CAPITAL EXPENDITURE FY 19

QUEENSLAND RAIL WEST MORETON SYSTEM

REVIEW OF SCOPE, COST AND STANDARD PRUDENCY

Figure 8.3: B.04636 Timber bridge replacement sites overlaid on West Moreton schematic

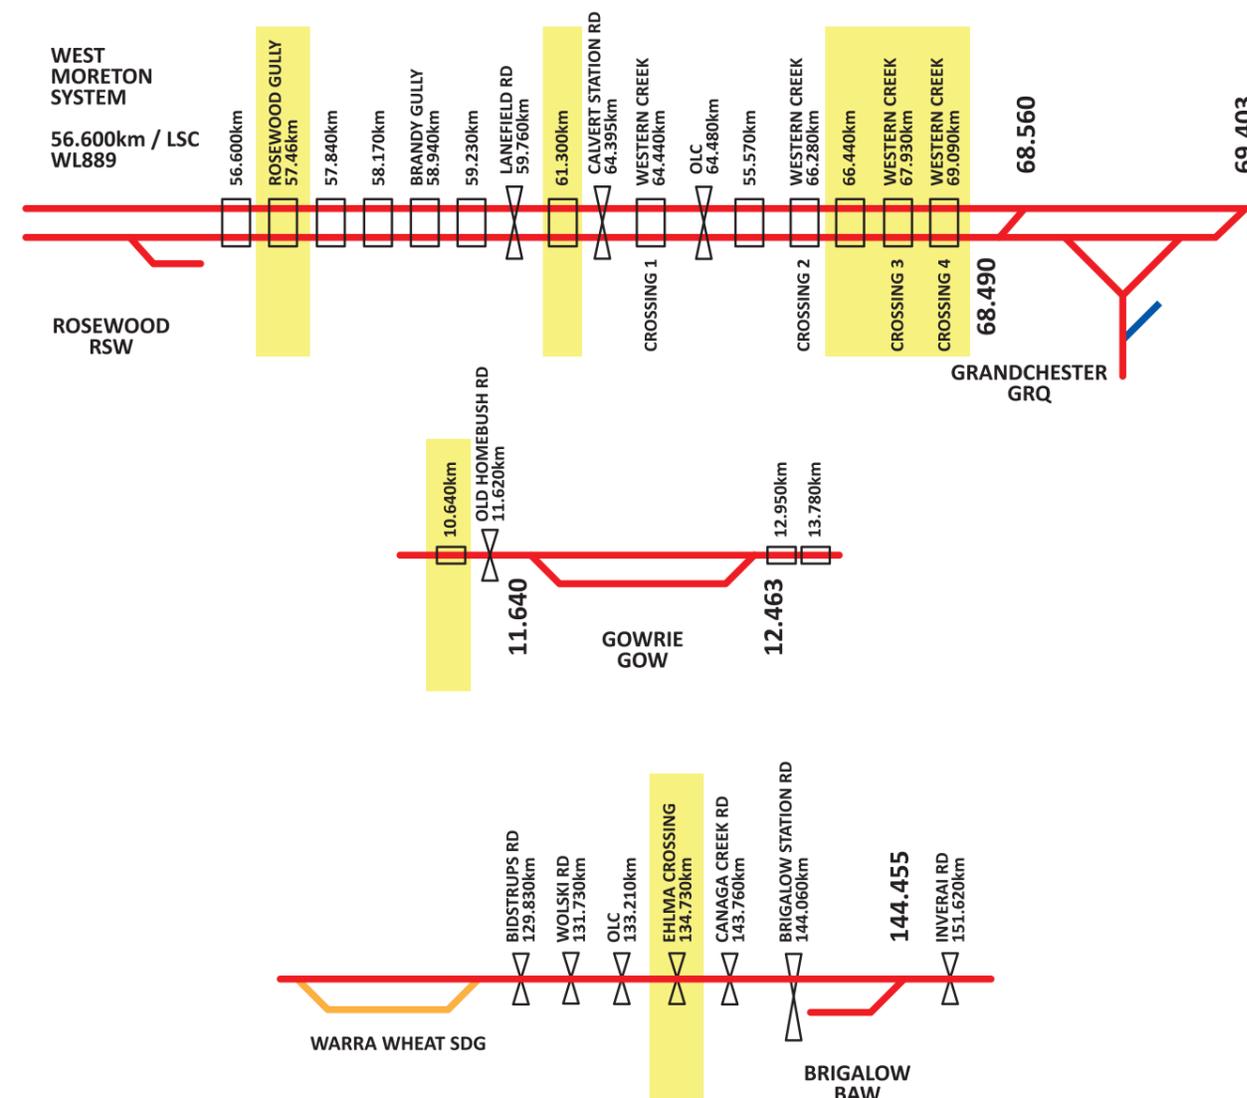
The locations of these seven bridge sites is shown on the extracts of the West Moreton schematics at Figure 8.3 below.

Figure 8.3 shows that:

Figure 8.4: Clusters of poor condition bridges reported by SYSTRA in 2019

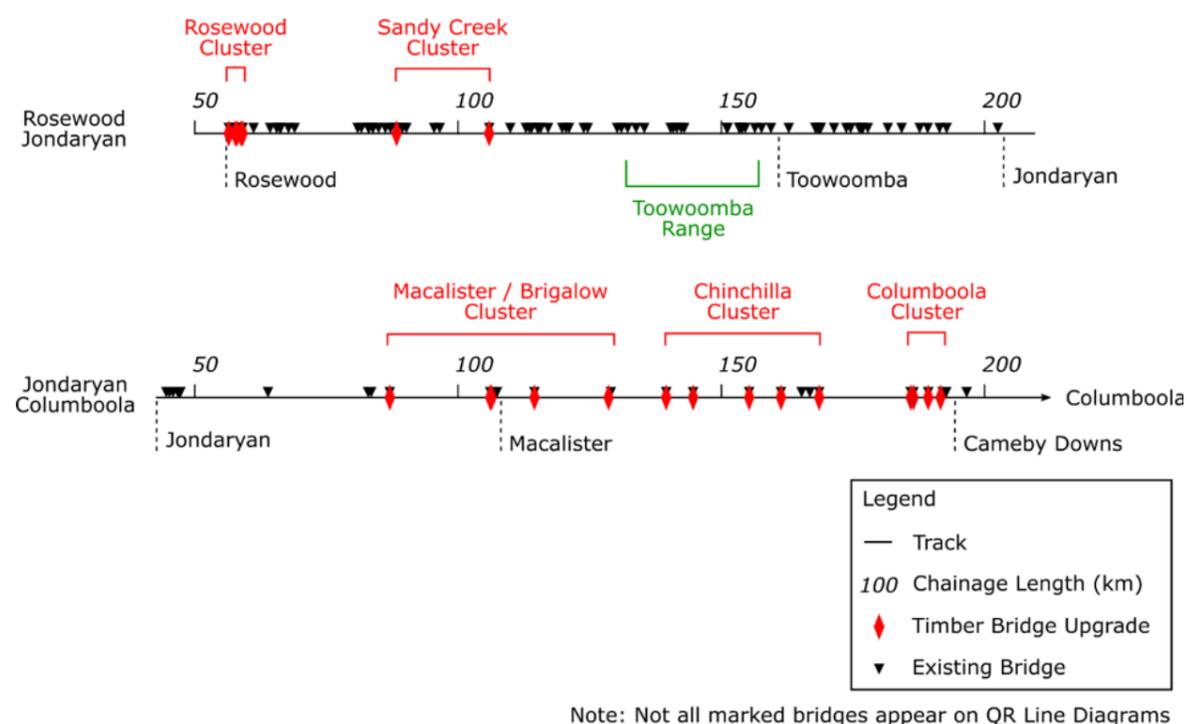
The five bridge sites clustered between Rosewood and Grandchester are adjacent a cluster of defective bridges reported by SYSTRA in the 2019 capital, maintenance and operations cost review, Figure 8.4 below is taken from that report. As these bridges were all built at the same time and are in the same topography, it is reasonable to consider these sites to be candidates for replacement.

Figure 8.6: Unit rate analysis based on normalised bridge costs (\$/square metre of the deck).

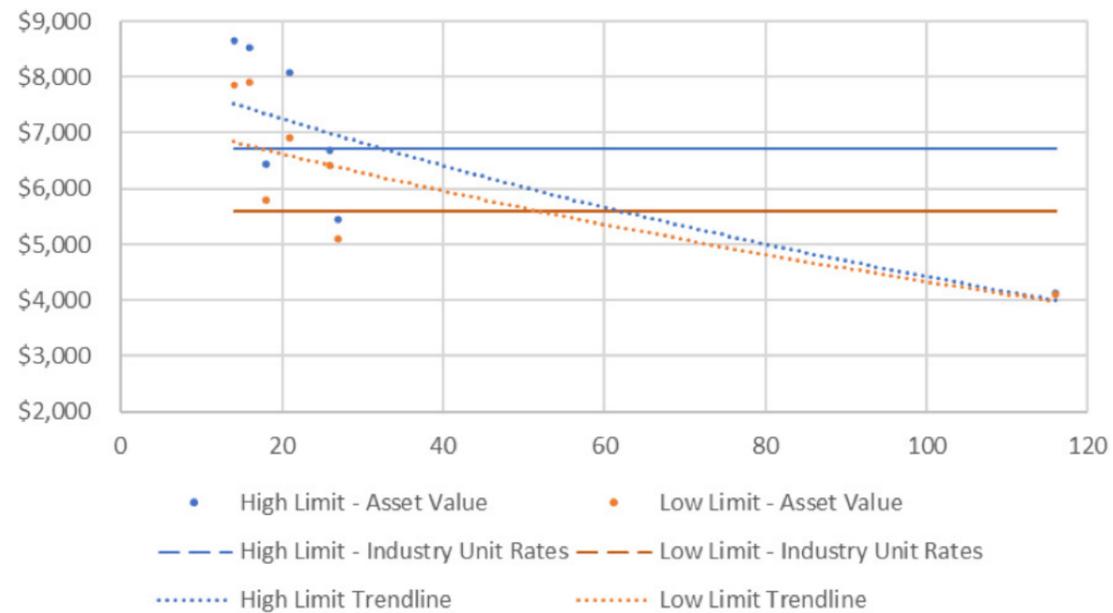
These Queensland Rail achieved rates are slightly higher than the FCG benchmark rates of [REDACTED]; however the FCG rates are “green field” and it is reasonable to expect that the Queensland Rail rates will be marginally higher due to the challenges of replacing bridges on an operating system. The Queensland Rail achieved rates for bridges align with industry benchmarking.

Figure 8.6 below shows these results graphically. This figure clearly illustrates the savings in unit rates for longer bridges.

Figure 8.7: Rosewood to Jondaryan resurfacing sites overlaid on resurfacing frequency FY 18

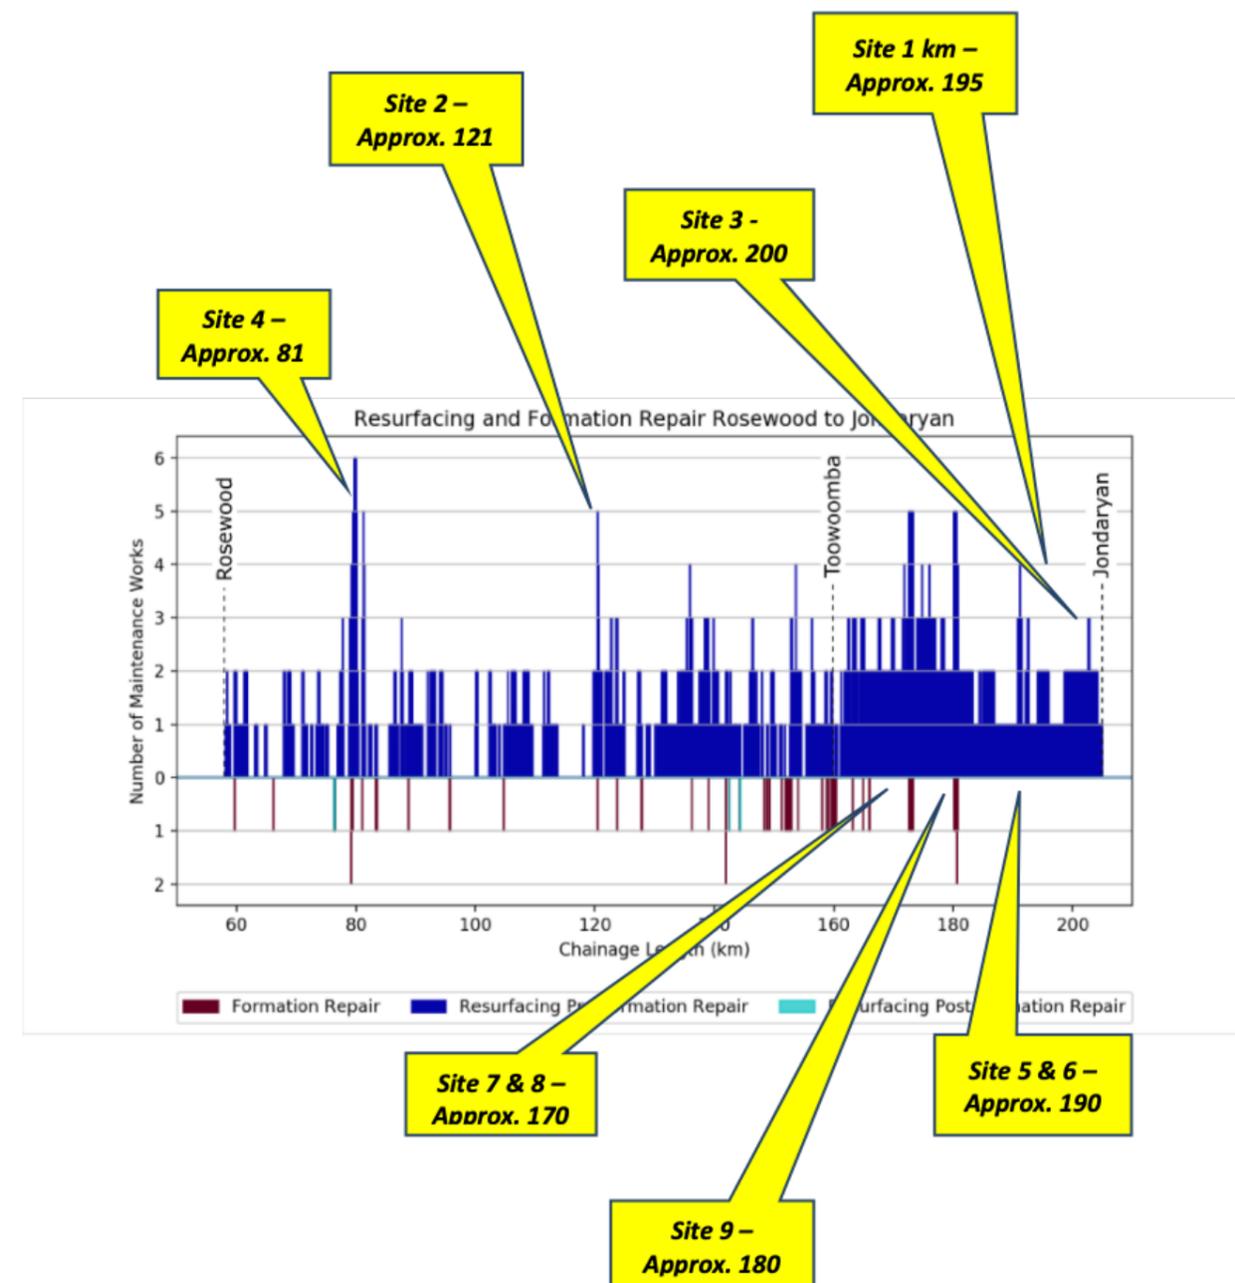
Overlaying these locations on the graphs prepared by SYSTRA showing resurfacing frequency³¹ by kilometre location validates whether these locations are sites that require continual maintenance to maintain track geometry through the frequency of resurfacing operations. This is shown below in Figure 8.7.

Figure 8.7 clearly shows that the sites selected by Queensland Rail for track reconstruction align very well with sites requiring excessive resurfacing operations on the Rosewood to Jondaryan corridor in FY 18. It should be noted that Queensland Rail have done no track reconstruction on the Jondaryan to Columboola corridor; this could be a conscious decision to maintain this corridor, with only 2.1 mtpa traffic, with minimum capital as fit for purpose. The lack of track reconstruction on Jondaryan to Columboola indicates very prudent commitment of capital and accounts for the shortfall identified early in this report.

Figure 8.12: Cross check of formation strengthening sites with multiple resurfacing operations at specific locations on J2C (FY 2017/2018)

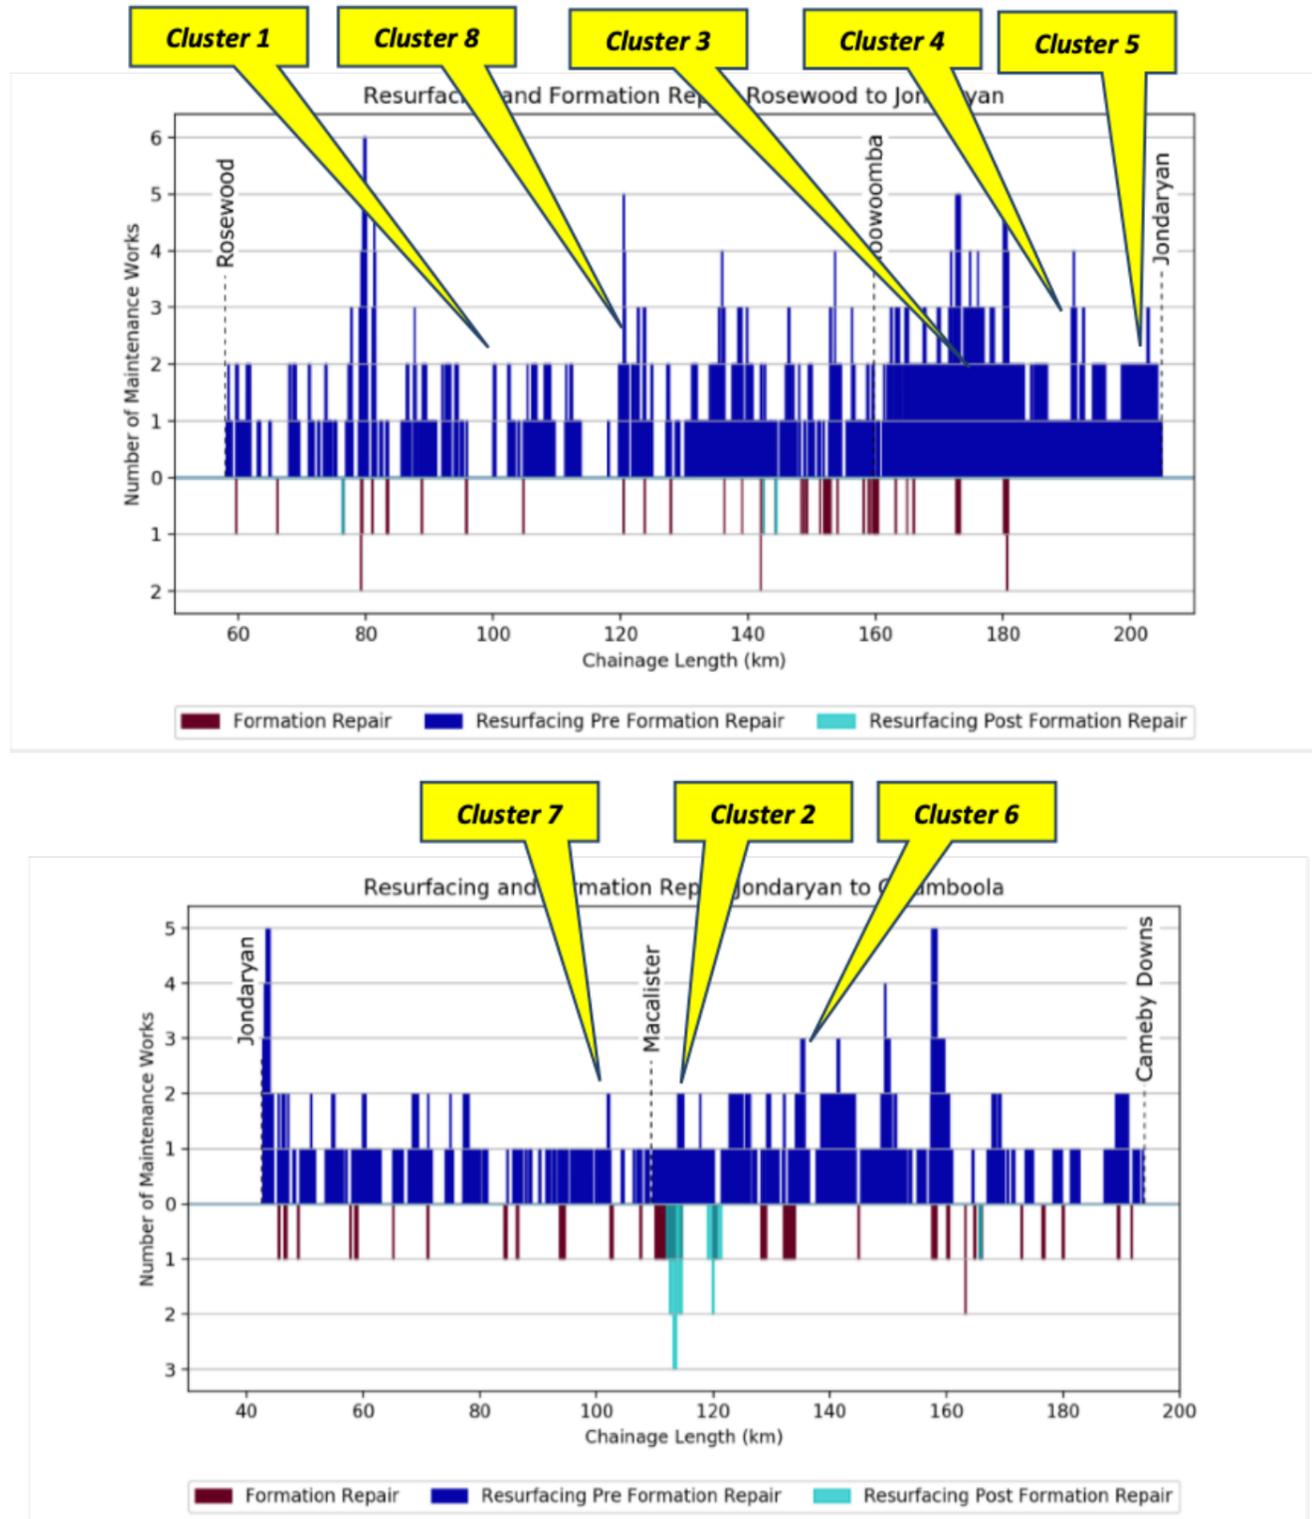
Cross checking these formation strengthening sites with Multiple resurfacing sites identified by SYSTRA is shown in Figure 8.12 below.

Figure 8.12 indicates that the formation strengthening sites are supported as valid candidates for formation strengthening through evidence of a general alignment with the requirement for multiple resurfacing operations to maintain track geometry.
